HISTORIC AND DESIGN REVIEW COMMISSION

April 03, 2019

HDRC CASE NO: 2019-154
ADDRESS: 908 E CROCKETT ST
LEGAL DESCRIPTION: NCB 583 BLK 8 LOT 7
ZONING: RM-4, H
CITY COUNCIL DIST.: 2
DISTRICT: Dignowity Hill Historic District
APPLICANT: Hayley Olliverre
OWNER: Dorian Shillingford
APPLICATION RECEIVED: March 18, 2019
60-DAY REVIEW: May 17, 2019
CASE MANAGER: Huy Pham

The applicant is requesting a Certificate of Appropriateness to amend an administrative approval of porch modifications to feature Craftsman-inspired forms including a gable roof and two additional columns on a non-Craftsman and non-contributing structure.

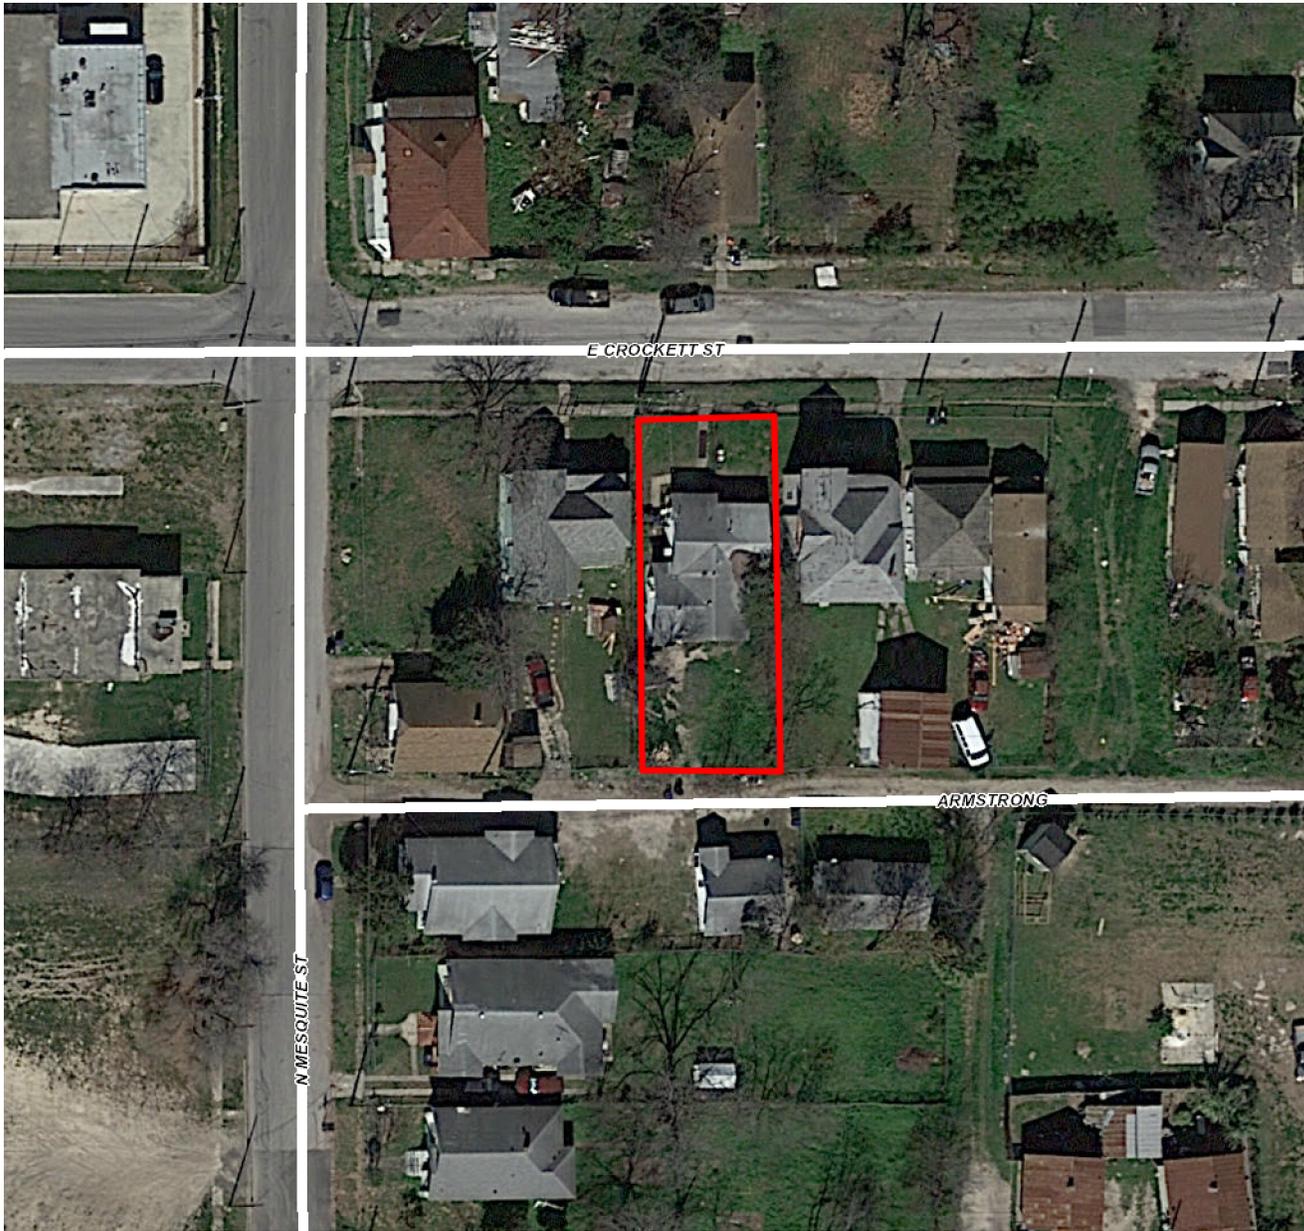
- c. VIOLATION – On a site visit conducted on February 19, 2019, staff found that the porch modifications did not match the plans submitted at the time of approval, most notably the inclusion of a porch gable. The owner/applicant explained to staff that they had modified their design from a shed roof to a gable-on-shed with other Craftsman-inspired elements. They were cooperative to submit a request on March 18, 2019, to be heard at the next available hearing.

- d. PORCH – The applicant is requesting to modify the front porch to feature a centered gable on the shed roof over the front gable and to include four (4) square columns instead of two (2) replaced existing columns. Per the Guidelines for Exterior Maintenance and Alterations 2.B.iv, new elements and details should not be added to create a false historic appearance and 2.B.iii., the design of replacement porches should be compatible in scale, massing, and details. Staff finds that the proposed design would create both false and inaccurate historicism by utilizing Craftsman forms and details on a simple non-Craftsman, non-contributing structure. Staff finds that the faux Craftsman-inspired porch modifications in addition to the large front façade aluminum windows and the front yard cattle panel fencing would be a departure and distraction to the contributing structures on E Crockett and the Dignowity Hill Historic District. Staff finds that the applicant should comply with the administrative approval by restoring the existing shed roof and replacement of the wrought iron columns with square wood columns and other updated but simplified details.

Staff does not recommend approval based on findings b through d. Staff recommends that the applicant complies with the administrative approval by restoring the existing shed roof and replacement of the wrought iron columns with square wood columns and other updated but simplified details. The front facing porch gable and two additional columns should be removed.

908 E Crockett
Proposed Front Facade

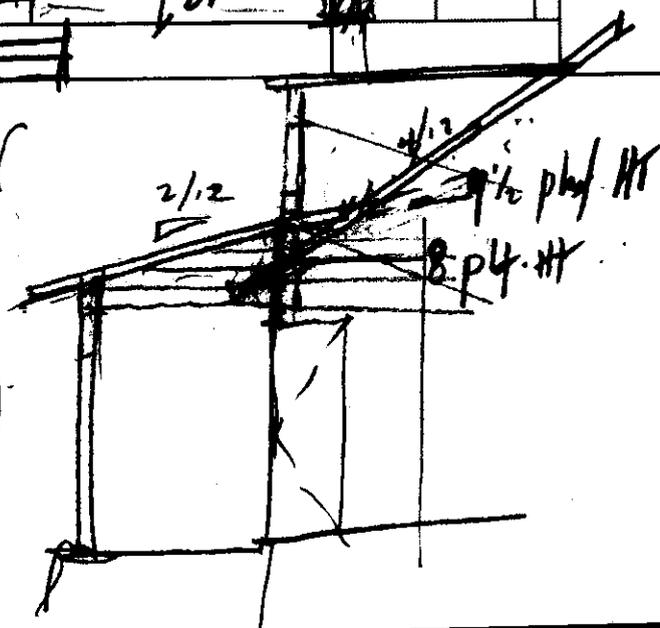
2 new wood columns,
see sample picture.

To highlight entrance,
create new raised roof line
over
porch extend over existing middle window
